جمهورية مصر العربية
هيئة قناة السويس

تحويل مستندات

- رد على تحويل مستنداتكم بخصوص إستفسارات الشركات في المناقصة رقم ٢٠٢٢/٥/١٥ جلسة الأحد الموافق ٢٠٢٢/٥/١٥ لتوريد وتركيب كاميرات مراقبة لمحطات المياه بمدن القناة الثلاث.

- الرد على الإستفسارات فيما يختص بكاميرات المراقبة وكافة ملحقاتها (ردود أجهزة الشبكة تختص به إدارة الاتصالات ونظم المعلومات والأعمال المدنية والكهربية تختص به إدارة الأشغال).
- رد على شركة جيزة للأنظمة (مرفق ١)
- رد على شركة إنتركوم (مرفق ٢)
- رد على شركة Interact (مرفق ٣)
- رد على شركة Netsync (مرفق ٤)
- رد على شركة Actel (مرفق ٥)
- رد مجمع على الشركات بخصوص الكاميرات (مرفق ٦)

محطة مياه بورسعيد

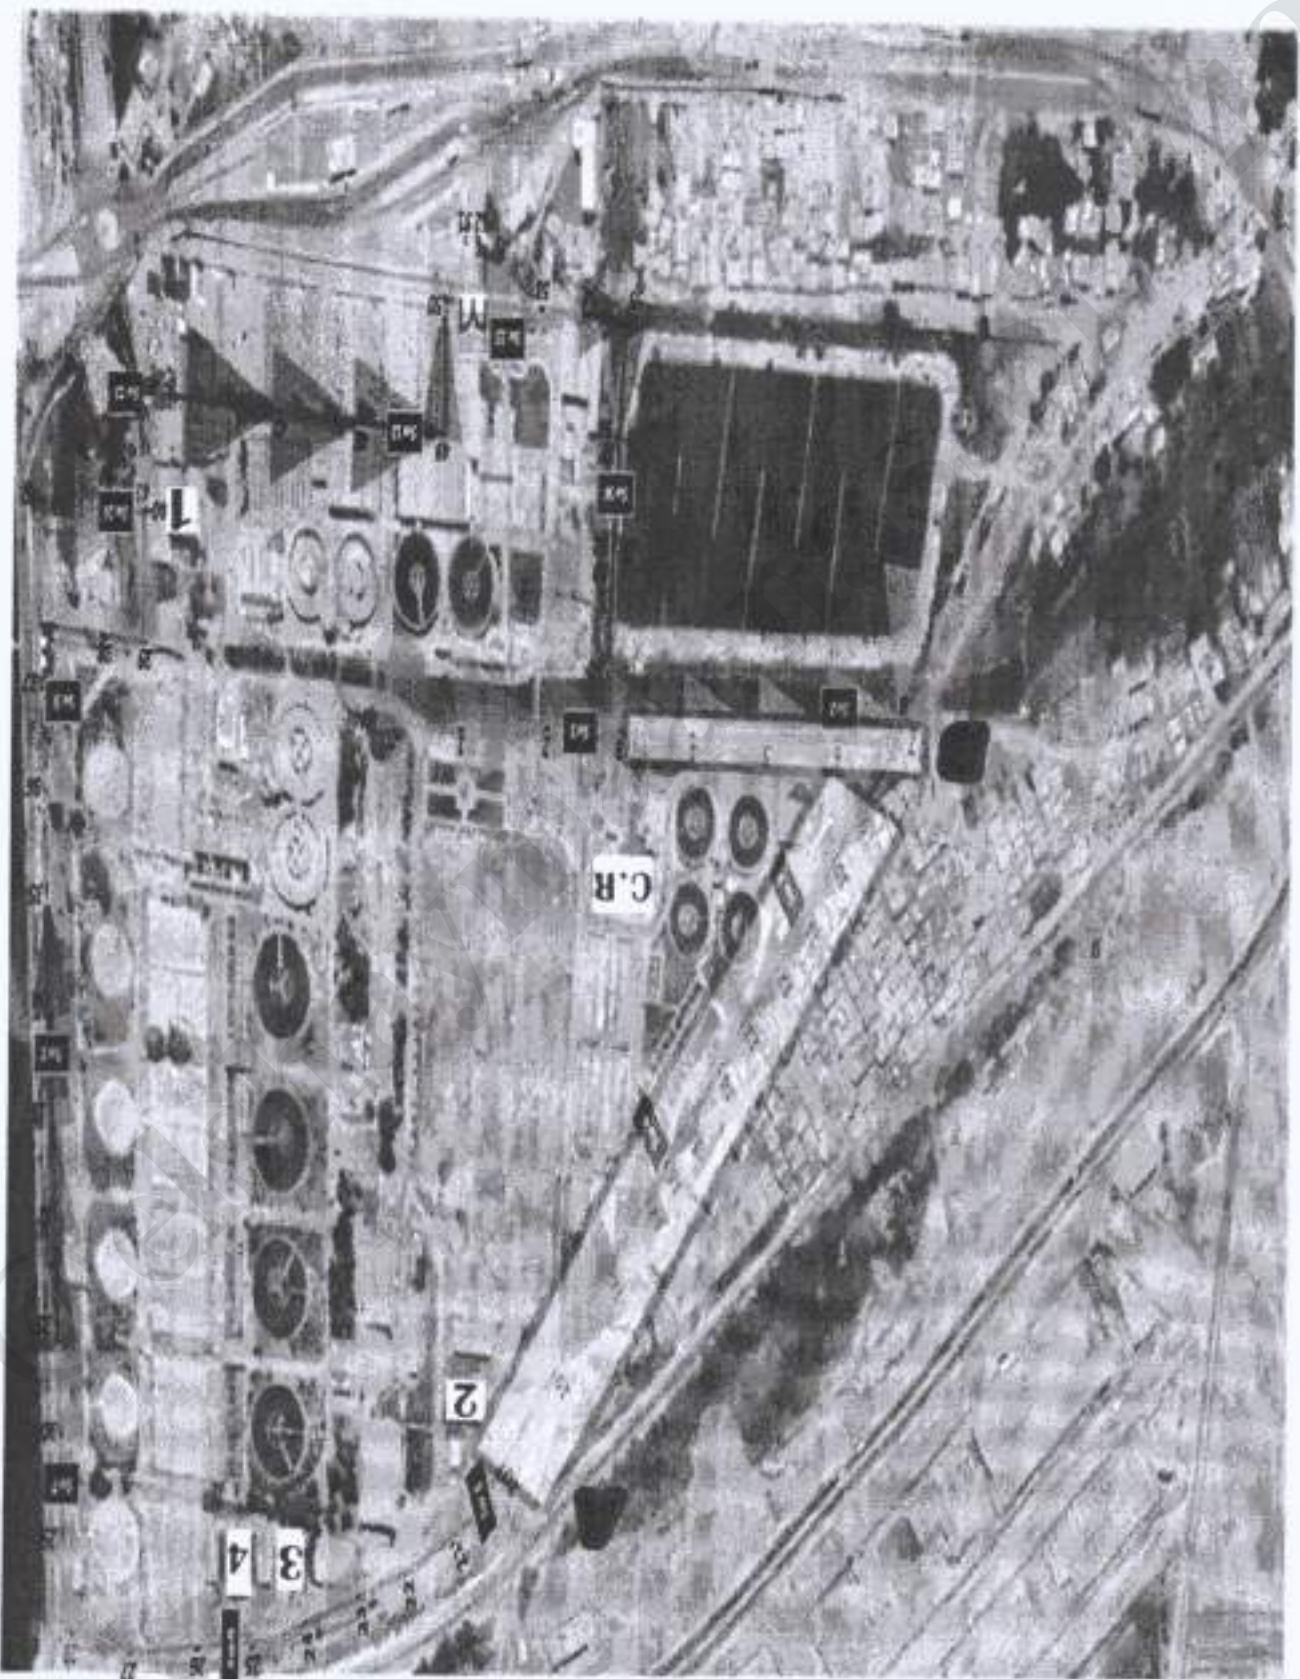
بالنسبة لمنطقة A سيتم
إضائه عدد 4 كاميرات
لتصبح المسافة بين
الكاميرات 25 متر بهذا
الضلع

و بالنسبة لمنطقة B
سيتم إضائه عدد 4
كاميرات لتصبح
المسافة بين الكاميرات
25 متر بهذا الضلع

محطة مياه
إلى سماء جبلية
بالنسبة لمنطقة A سيتم
إصلاؤه عند 4 كاميرات
لتفصيل المسألة بين
الكاميرات 25 متر بهذا
الضلع

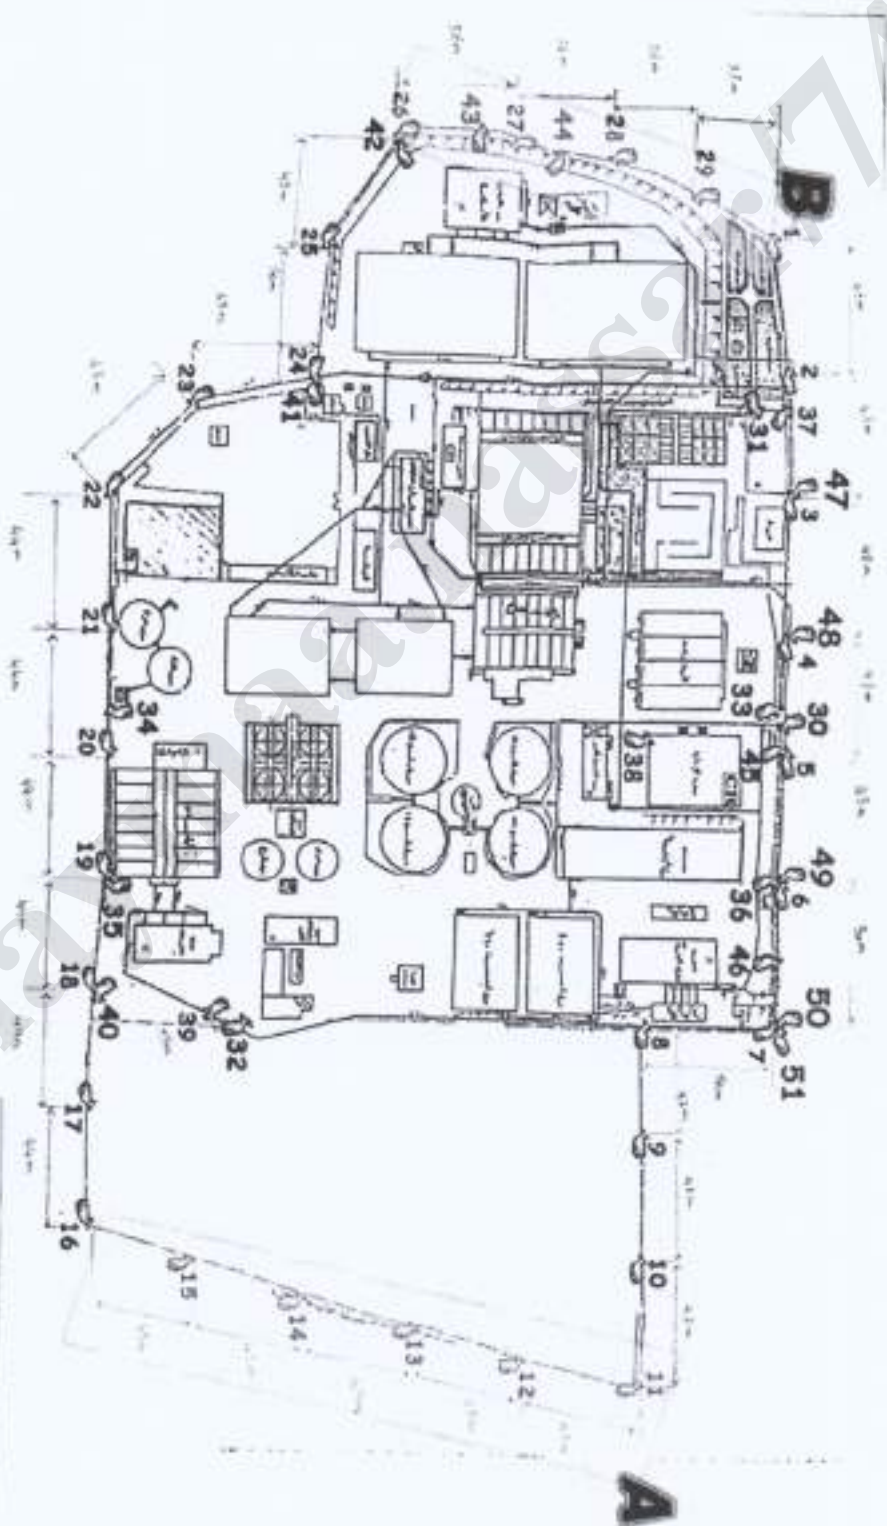
و بالنسبة لمنطقة B
سيتم إصلاؤه عند 2
كامير لتفصيل المسألة
بين الكاميرات 25 متر
بهذا الضلع

Fence	1 -> 29
Gates	30, 31, 32
Ways	33, 34, 35, 36
Chlorine station	37, 38, 39
Ware house	40 -> 45
Taker	46 -> 51

محطة مياه بورسعيد

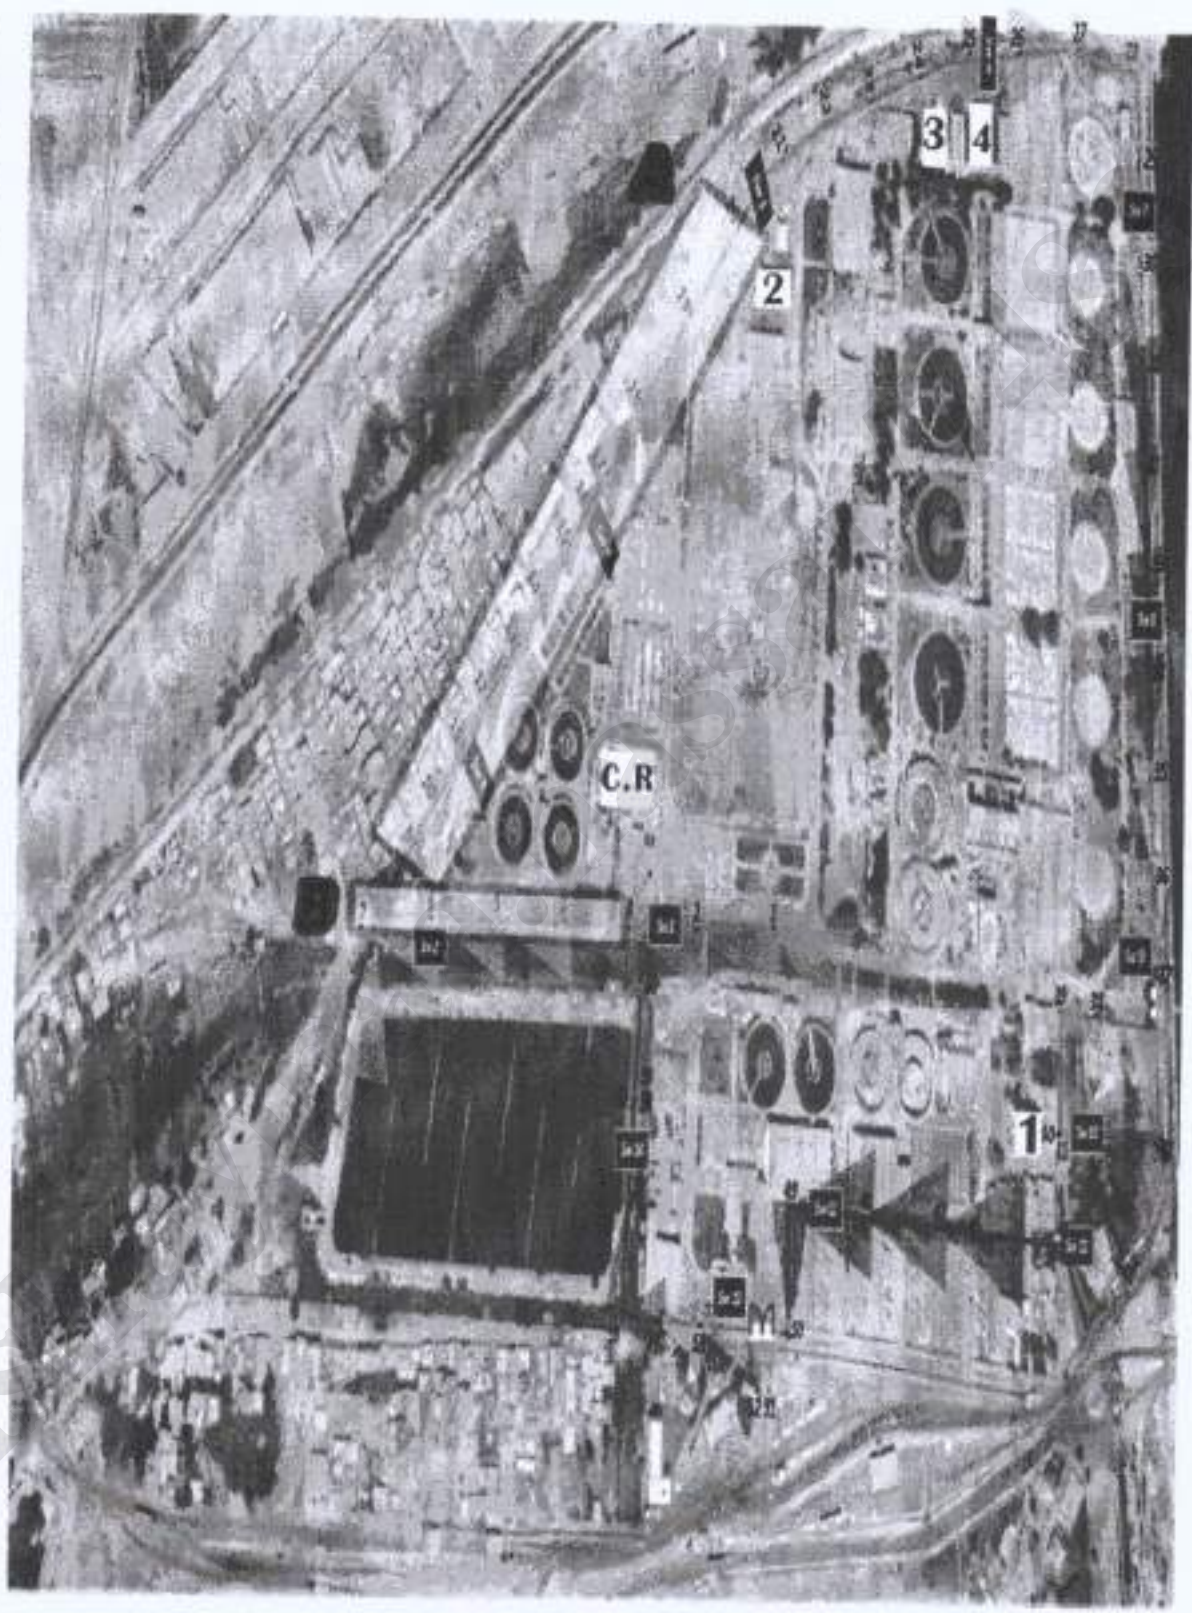
بالنسبة لمنطقة A سيتم
اضافه عدد 4 كاميرات
لتصبح المسافة بين
الكاميرات 25 متر بهذا
الضلع

و بالنسبة لمنطقة B
سيتم اضافة عدد 4
كاميرات لتصبح
المسافة بين الكاميرات
25 متر بهذا الضلع

محطة مياه

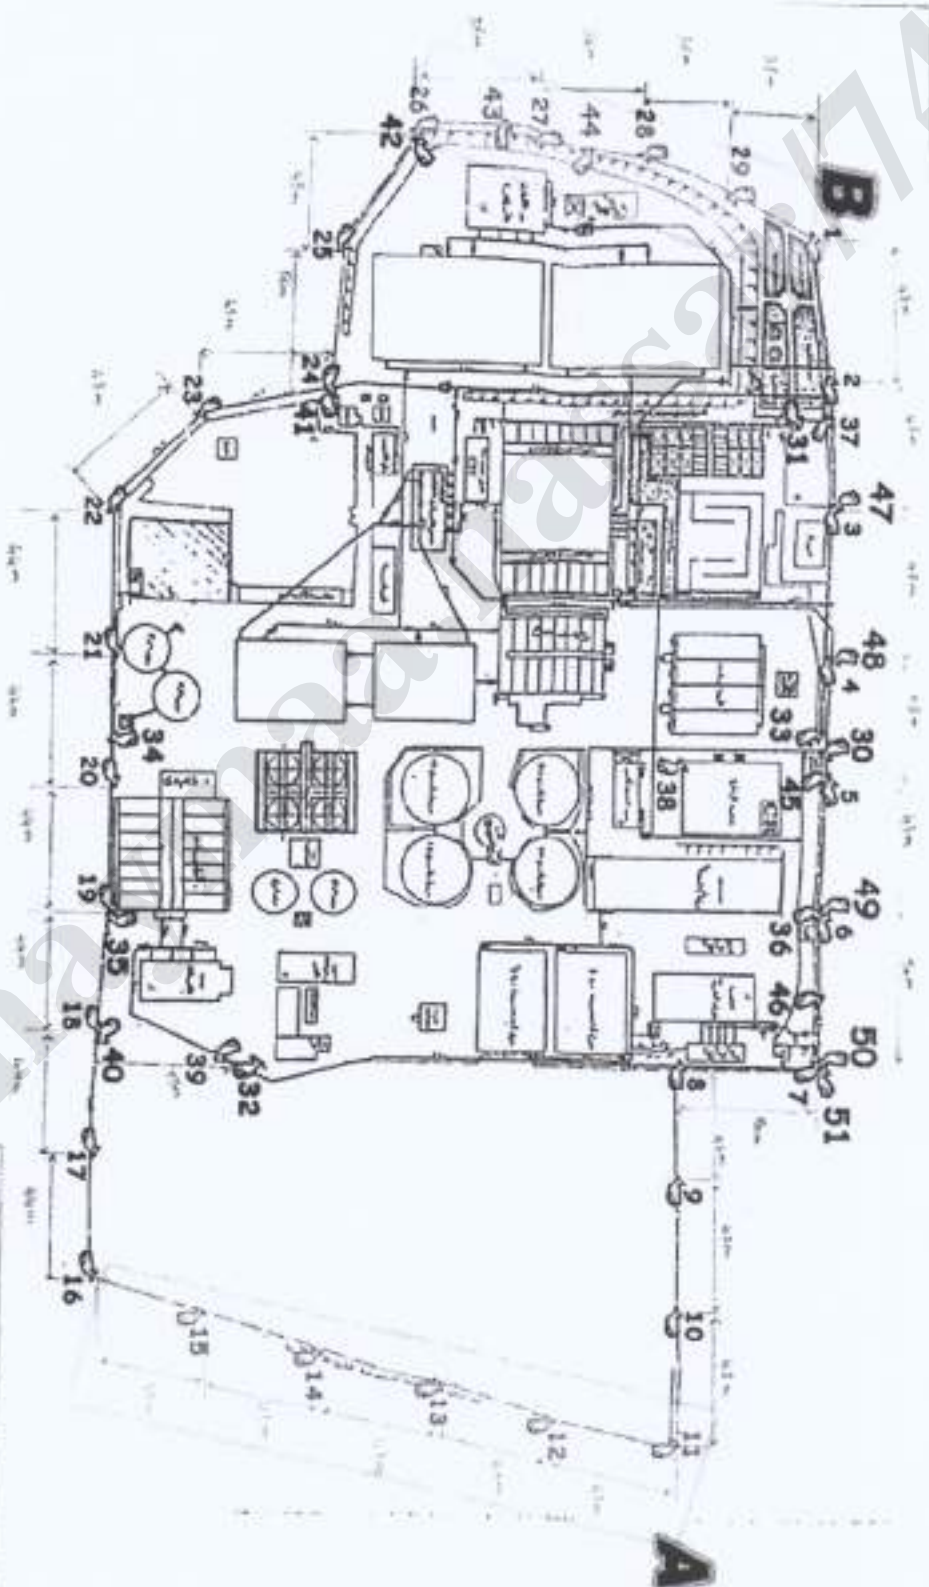
بالنسبة للمنطقة A سيتم

إضافته عدد 4 كاميرات

لتصبح المسافة بين

الكاميرات 25 متر بهذا

الضلع

و بالنسبة للمنطقة B

سيتم اضافته عدد 2

كاميرا لتصبح المسافة

بين الكاميرات 25 متر

بهذا الضلع

Fence	1 -> 29
Gates	30, 31, 32
Ways	33, 34, 35, 36
Chlorine station	37, 38, 39
Ware house	40 -> 46
Taker	47 -> 51

محطة مياه بئر سعيدي

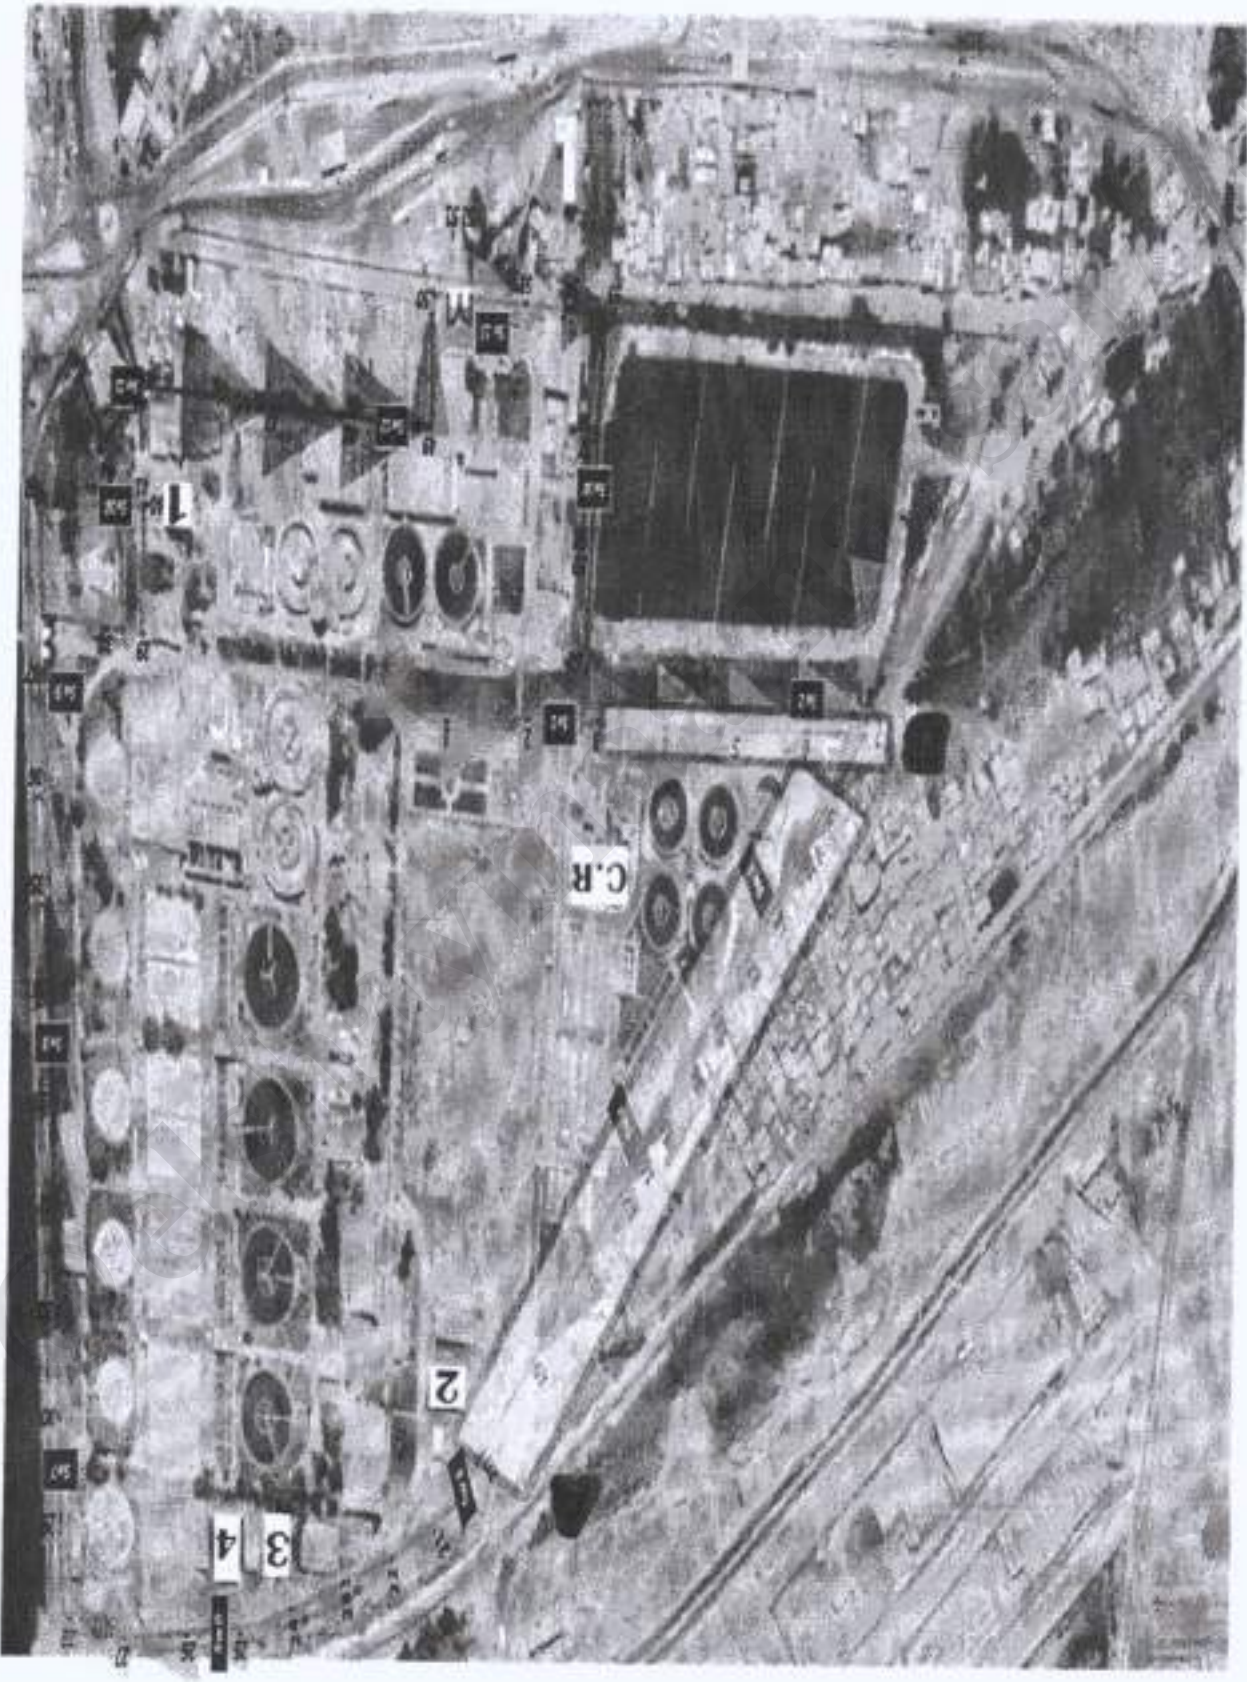
بالنسبة لمنطقة A سيتم
اضافه حدة 4 كاميرات
لتصبح المسافة بين
الكاميرات 25 متر بهذا
الضلع

و بالنسبة لمنطقة B
سيتم اضافته حدة 4
كاميرات لتصبح
المسافة بين الكاميرات
25 متر بهذا الضلع

محطة مياه
الإسما عينية
بالنسبة لمنطقة A سيتم
إضافته عند 4 كاميرات
لتصبح المسافة بين
الكاميرات 25 متر بهذا
الضلع

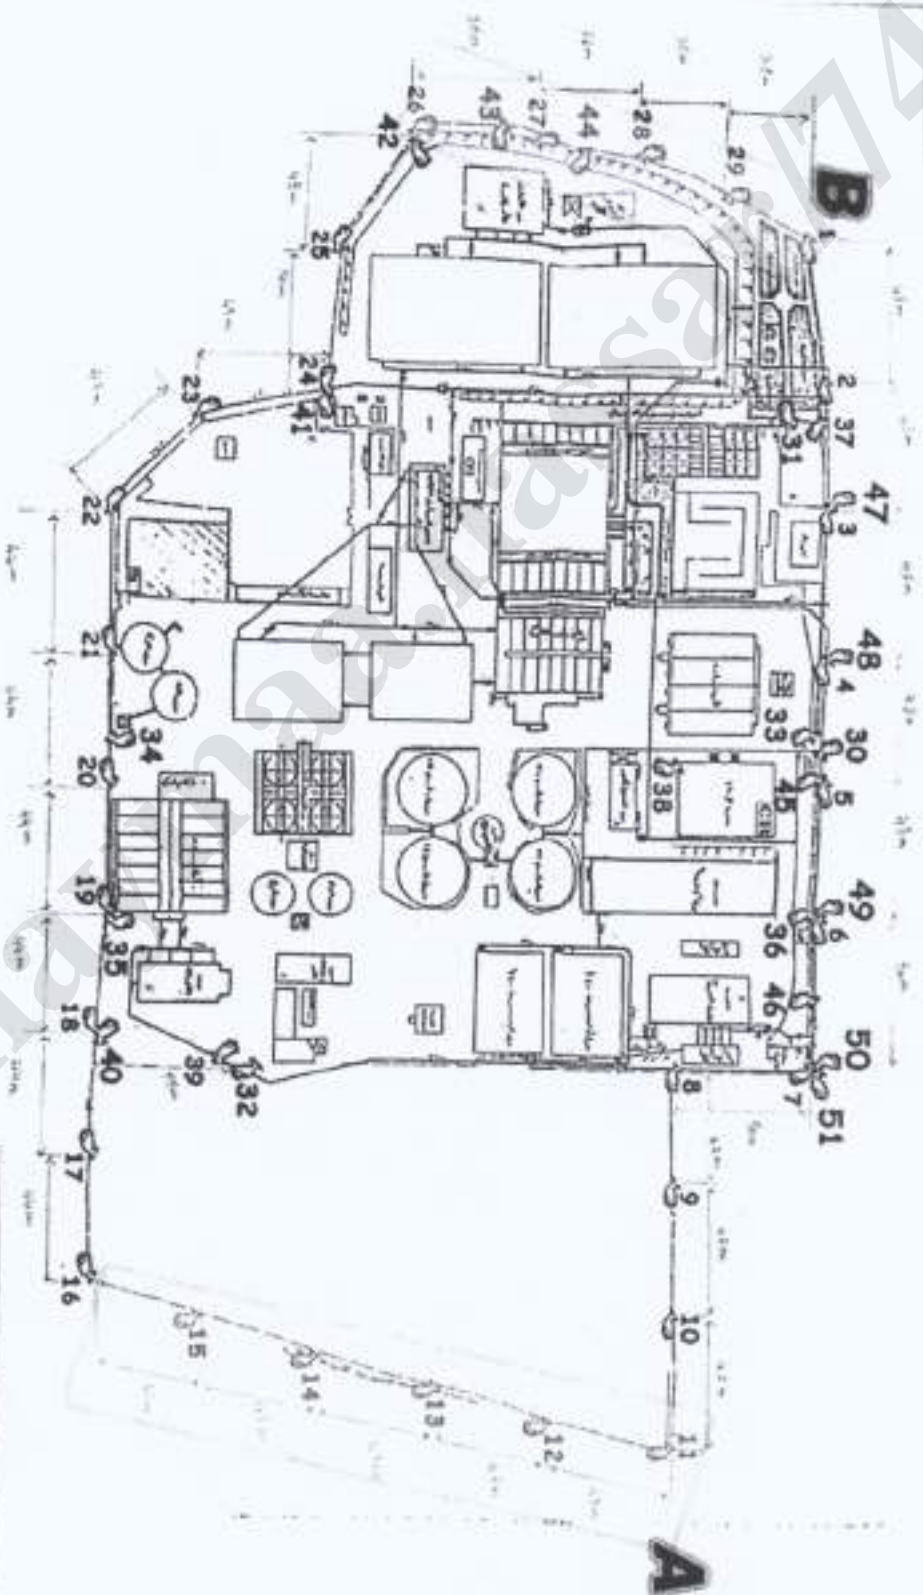
في النسبة لمنطقة B
سيتم اضافته عند 2
كاميرات لتصبح المسافة
بين الكاميرات 25 متر
بهذا الضلع

Fence	1 -> 29
Gates	30, 31, 32
Ways	33, 34, 35, 36
Chlorine station	37, 38, 39
Ware house	40 -> 46
Taker	47 -> 51
